**STAFF RECOMMENDATION**

**1620 Holly Street**

**May 15, 2013**

**Application:** Request for a rehearing

**1 FIRST FLOOR DEMOLITION PLAN**

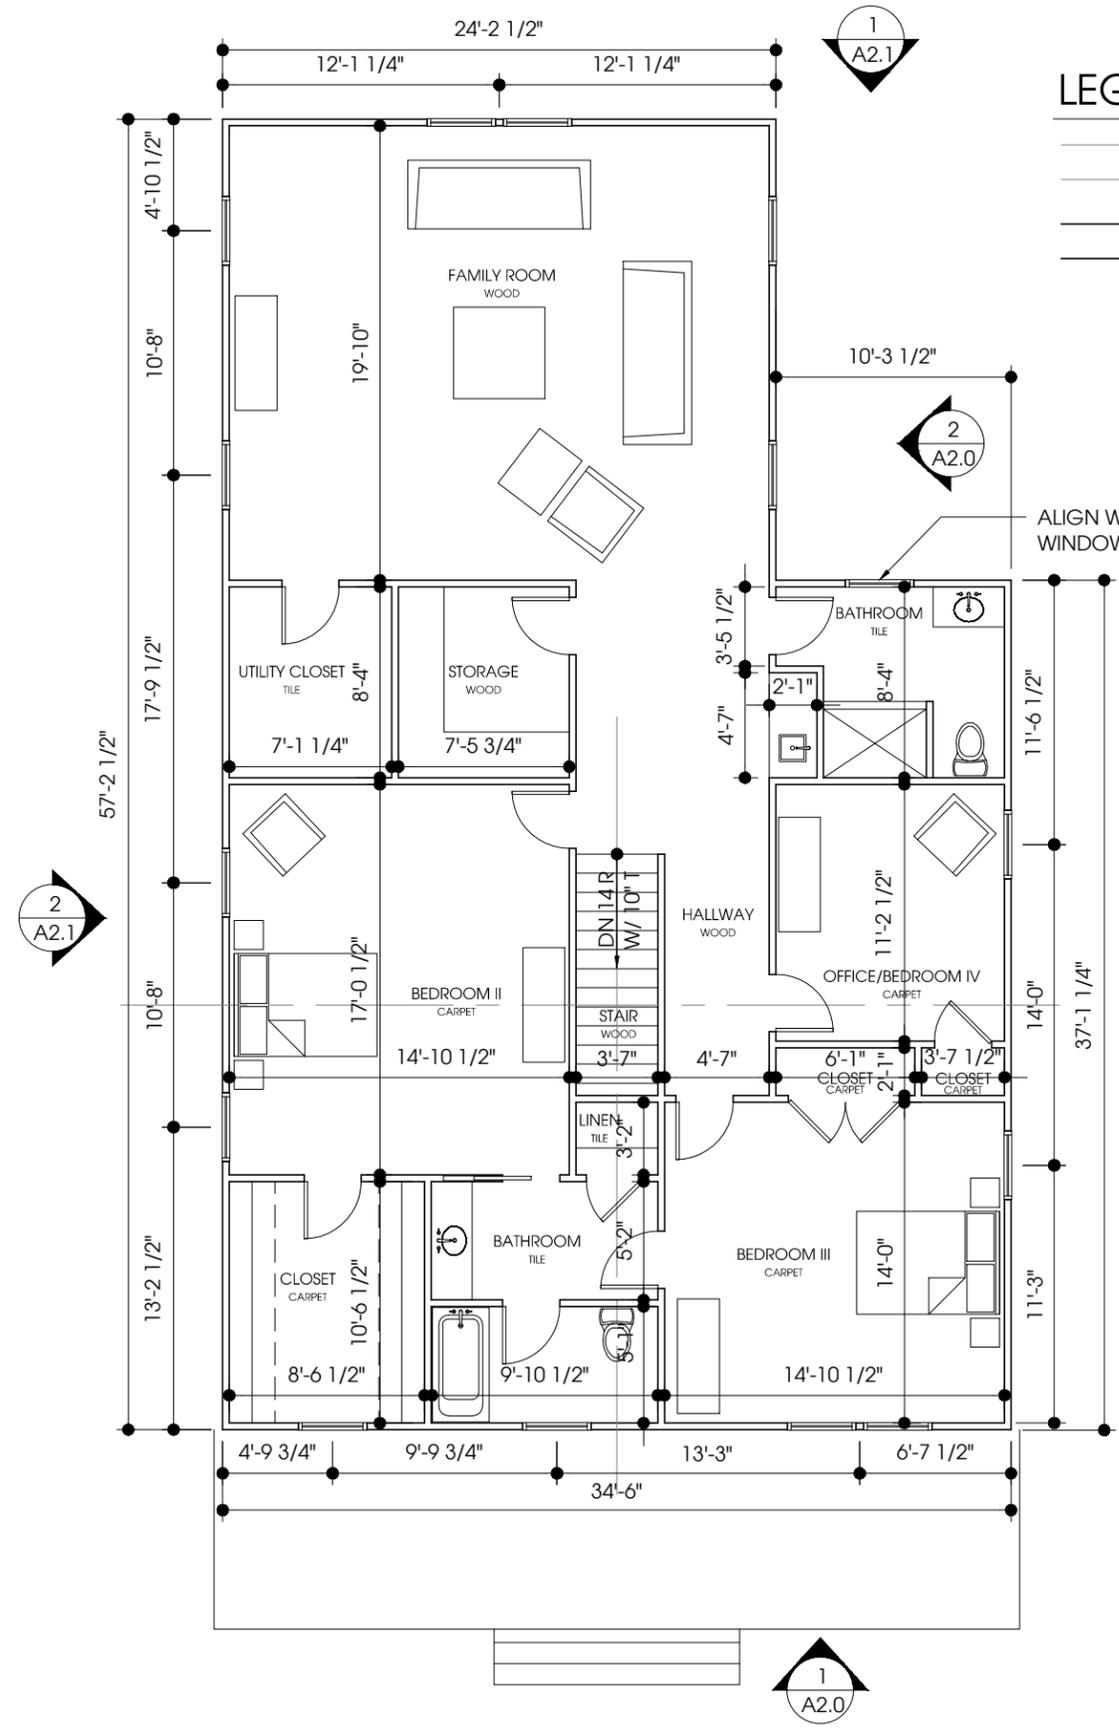
The applicant has submitted plans, greatly revised from the previously approved scope of work, in which they propose to demolish the roof and interior walls of the existing building in order to enlarge the house, keeping the foundation, first floor front and side walls, and an existing front-facing attached garage. In determining whether the proposed work is truly an addition or new construction of a primary buildings, Staff considered whether or not the existing house could accommodate a second level. An engineering report addressing that issue was requested but not submitted. In similar projects in the past, attempts to reuse even just an existing foundation have ultimately been found not to be structurally feasible. Concerned that the existing building likely cannot accommodate a second level, and because the majority or entirety of the finished project would be new material, Staff reviewed the project as new construction of a primary building, rather than as an addition.

Because the existing structure does not contribute to the historic character of the district because of its age and design, staff finds the demolition of the structure in full to meet guideline IV.B.2.b. An existing rear shed will be retained.

Staff recommends approval of the application to demolish the non-contributing house and construct a new two-story house, with the conditions that:

1. The attached front-facing garage and driveway be eliminated;
2. The scale of the new building be reduced by detaching the attached rear-left garage;
3. The long two-story wall and continuous roof plane on the left side of the house be broken up or articulated;
4. The foundation height be indicated on the exterior by a change in material, water table, and/or rowlock.
5. Additional windows be added to the sides;
6. The shutters either be eliminated or designed to be operable;
7. The materials, textures, details, and colors (including the siding texture and reveal, the materials and colors of the foundation, brick stain, windows, doors, trim, roof, sidewalks and front steps) are approved administratively, and that cornerboards are added where needed,

**2 SIDE (WEST) ELEVATION**

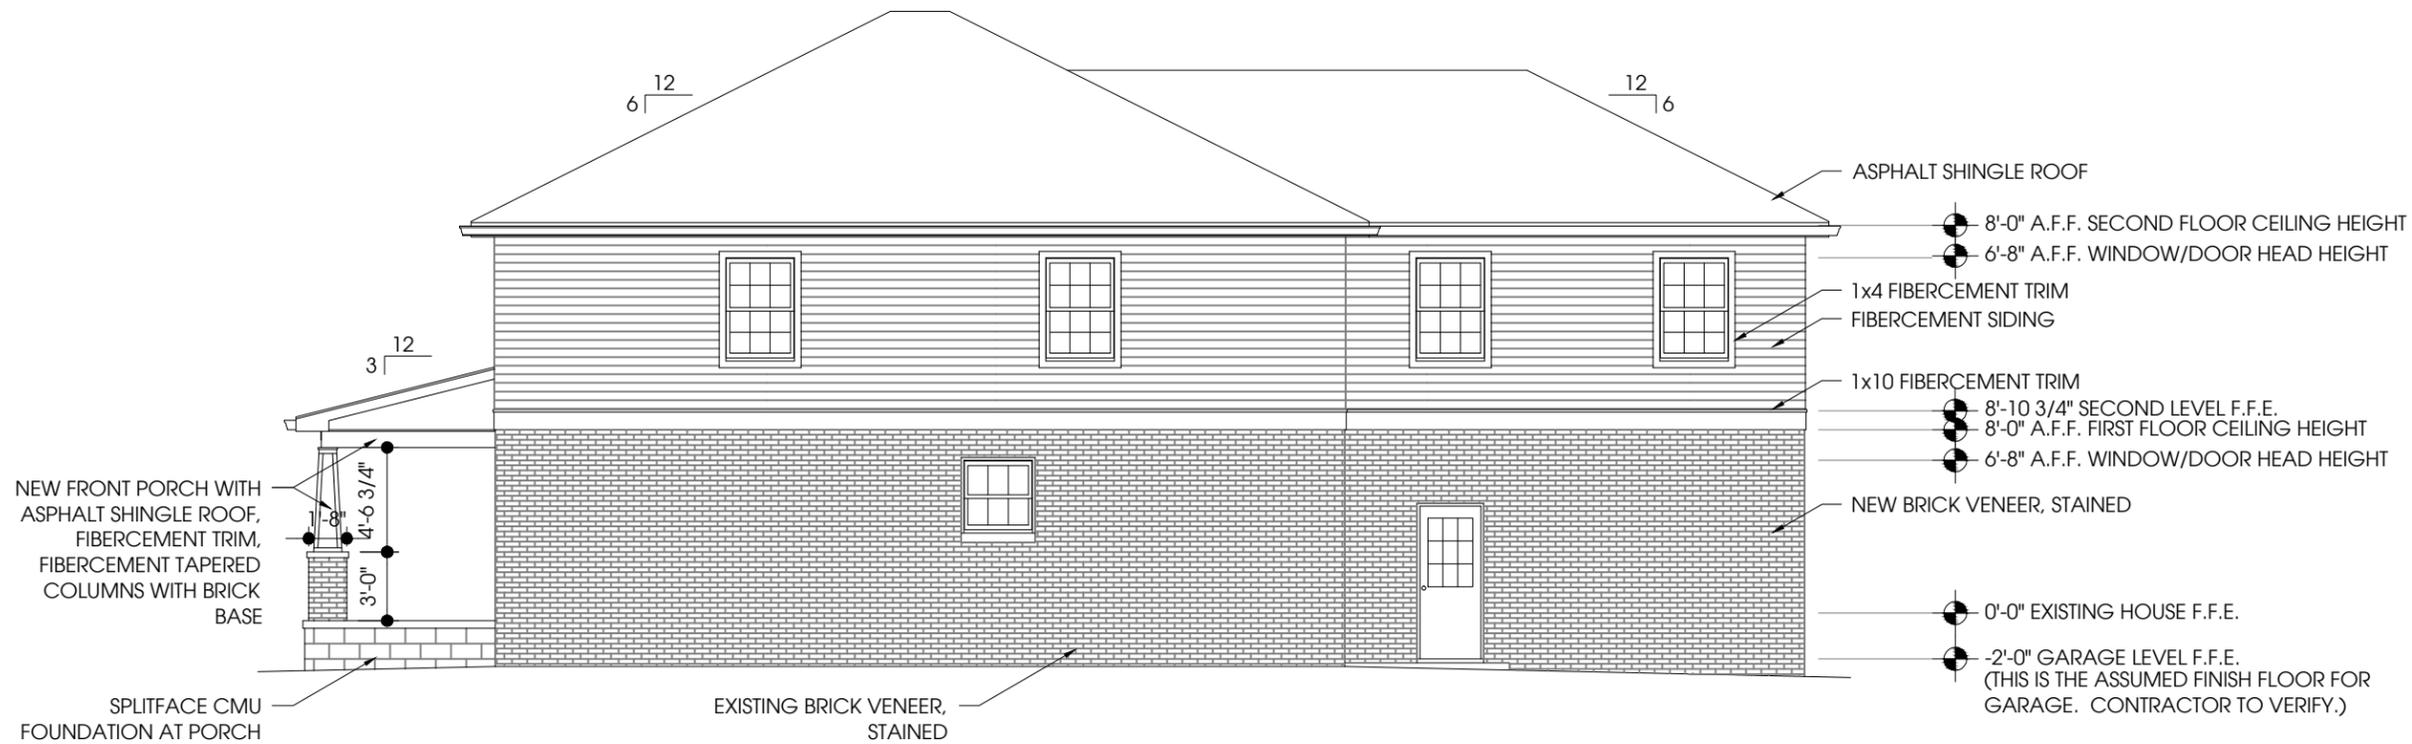
The width of primary mass of the new building would match that of the existing house, with a thirty-five foot (35') wide front wall, but it would retain an existing eleven foot (11') wide front-facing attached garage on the left side of the non-contributing building. The primary wall is compatible with the widths of surrounding historic houses, which range from twenty-two feet (22') to thirty-eight feet (38') in width, but the forty-six foot (46') total width would be greater than is typical of historic houses. Staff finds that retaining the existing attached garage with the new building does not meet guidelines II.B.2. and II.B.3.

With the footprint of the primary mass of the new building matching that of the existing building, the depth of the house (front to rear) is roughly the same on the right side, but there will be an eight foot (8') deep full-width porch added to the front. The left side, however, will be extended twenty-eight feet (28') to the rear to accommodate an attached two-car garage with a family room on the second story. Staff finds the new left wall more than fifty-seven feet (57') deep with a nineteen foot (19') eave, without any articulation of wall-planes, to be incompatible with the scale of historic houses. Reducing the scale of the rear portion would result in a more appropriate massing in order to meet guidelines II.B.2. and II.B.3.

The applicant’s proposal is to attempt to retain the front and side walls for the first story of the new building, therefore the front and side elevations will maintain existing window patterns and proportions; however, as stated previously, staff has reviewed the project as full new construction. On the front elevation, the existing openings are asymmetrically placed but are generally appropriate in proportion to the window patterns of historic houses. Shutters are shown on the front elevation windows, which would not be appropriate unless they are operable. The side elevation window patterns, however, are not appropriate. The right side would have only one small window behind the midpoint of the primary “Foursquare” mass, and the left side would have a single door behind the midpoint of the structure. The existing attached metal garage would occupy the majority of the left wall of the “Foursquare.” Staff recommends adding a vertically oriented window to the ground level, right side, towards the front of the house and one or two windows on the ground level where the current side garage is proposed. The windows in the upperstory are regularly spaced and compatible on all three public facades. With the condition of additional windows on the side, Staff finds the window patterns of the upperstory and front elevation to meet guideline II.B.7.

- 8. Cornerboards be added where needed; and
  - 9. Revised drawings be submitted to reflect any and all approved conditions.
- Having met those conditions, staff finds that the application would meet the design guidelines for New Construction in the Lockeland Springs-East End Neighborhood Conservation Zoning Overlay.

**2 SIDE (EAST) ELEVATION**

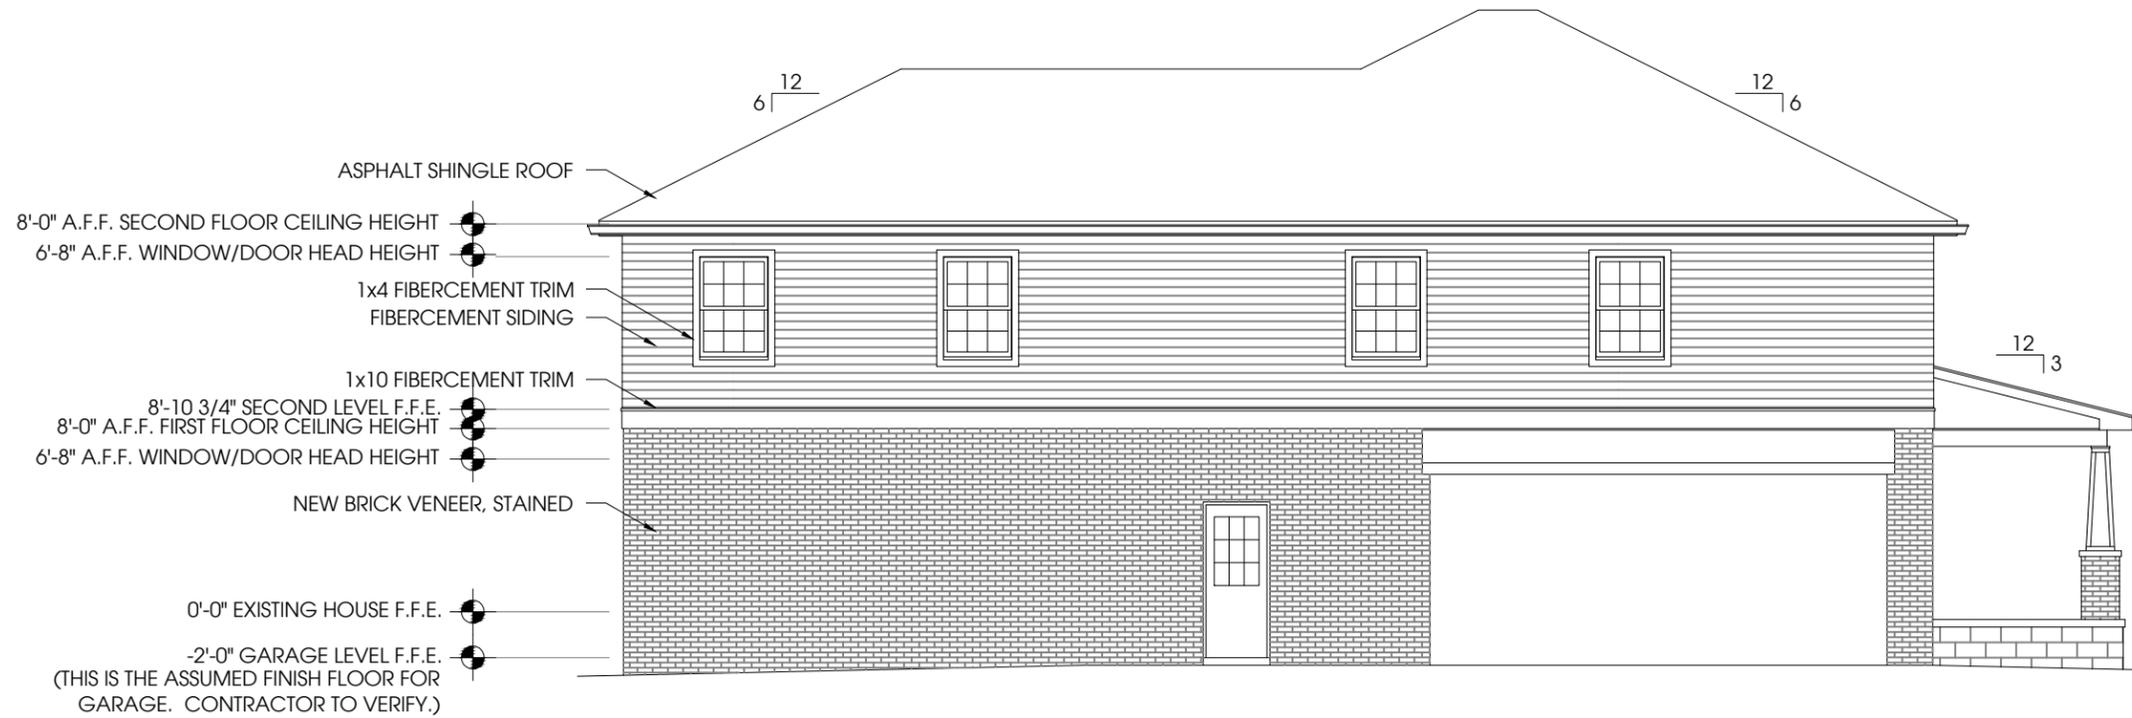
Staff finds the two attached garages on the new building do not meet guideline section II.B.8.

FRONT

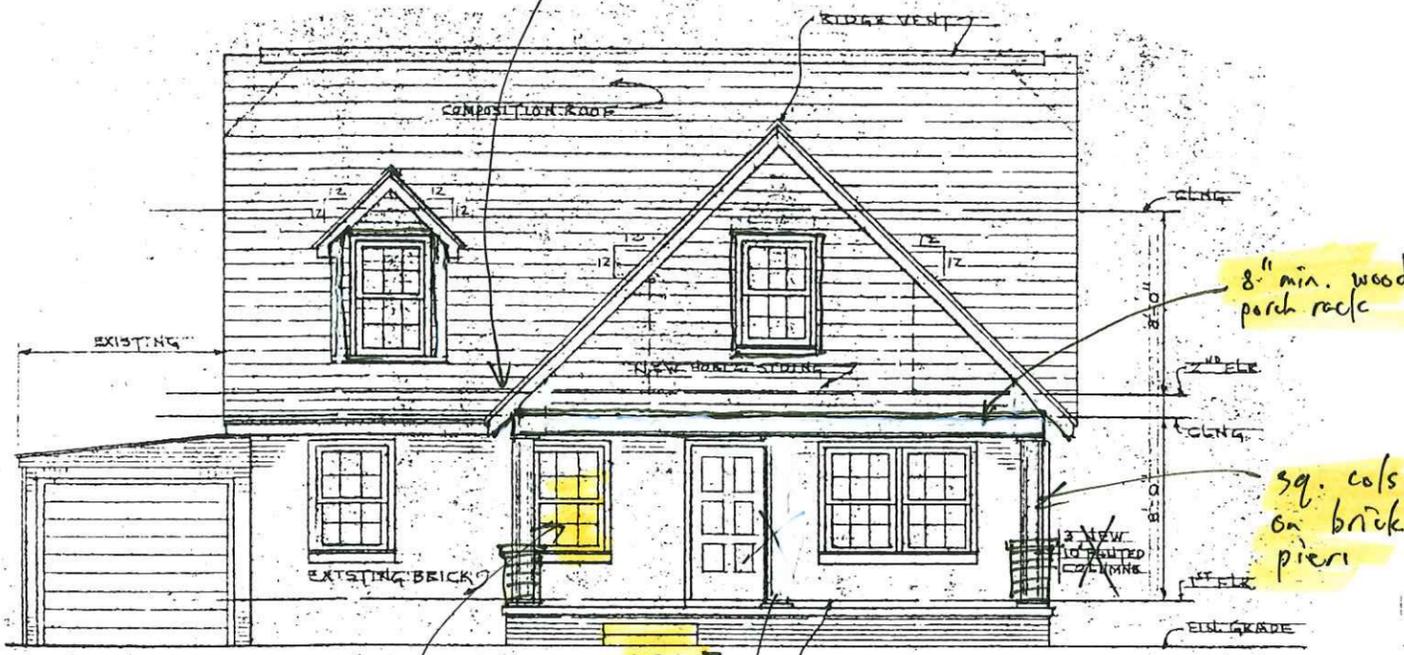
open rafter tails @ front porch

RIGHT

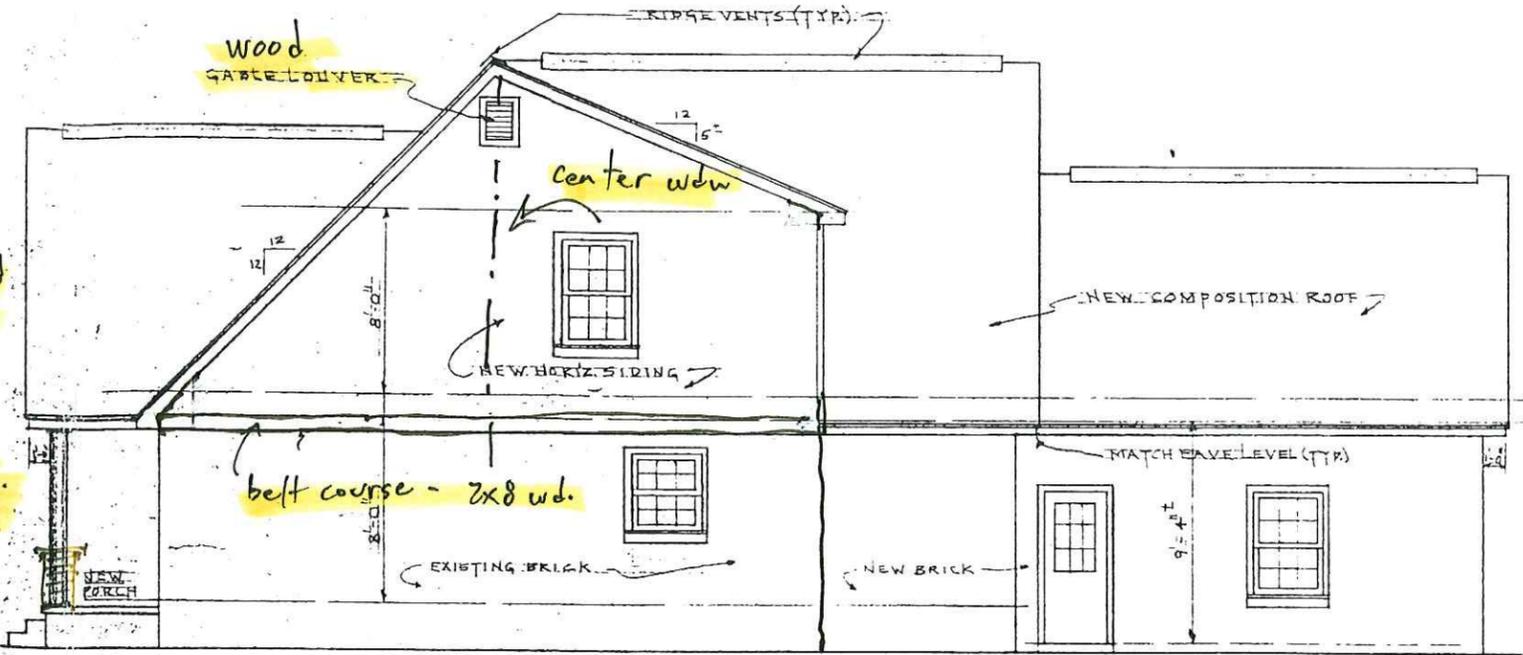
Enlarge wdw. so that bathroom wdw has same top & sill ht. as all other 1st floor front wdws.

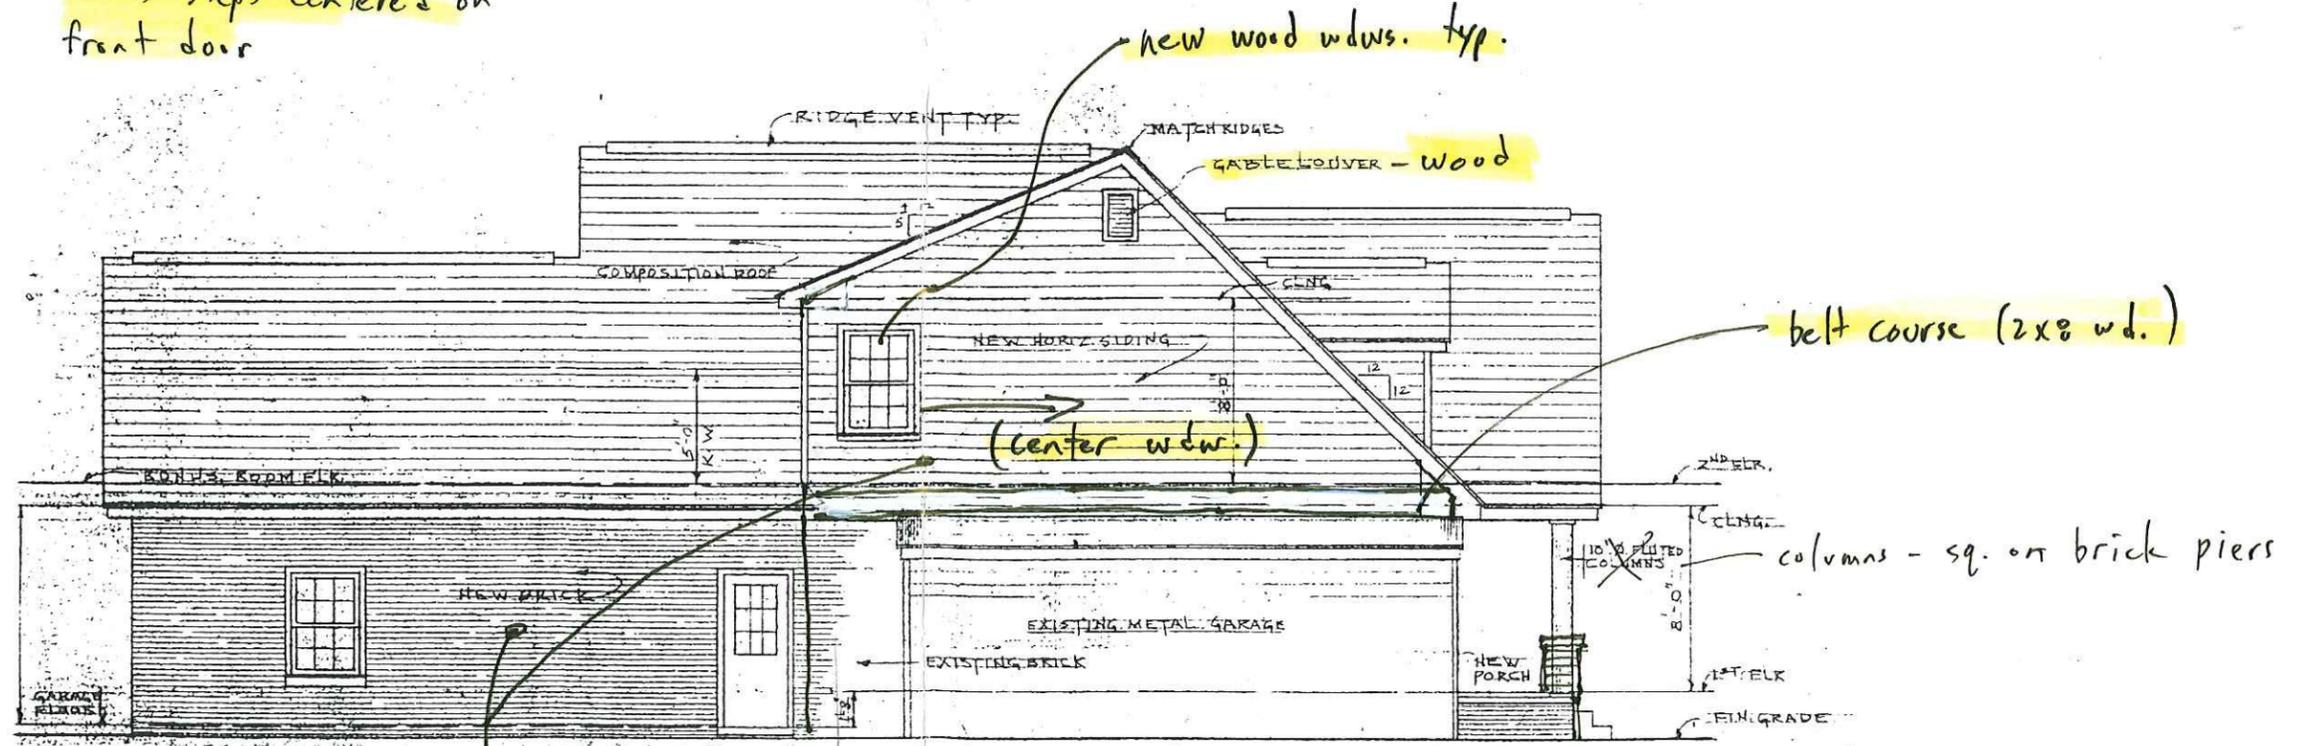
Remove column  
Front steps centered on front door

hardiplank siding, typ.
